Access Compliance Report

Public Rights-of-Way

(Pedestrian Signals)

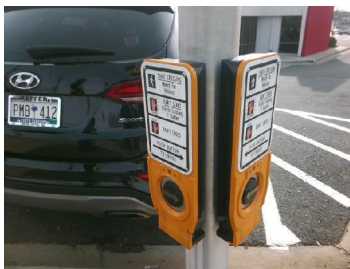
PROW/ADA: TMUTCD 4e.08, R404.2, R404.3, R406.2, R404.7.3

Possible Solutions: Replace Signal Push Button With APS Button on New Post. Remove & Relocate Sign.
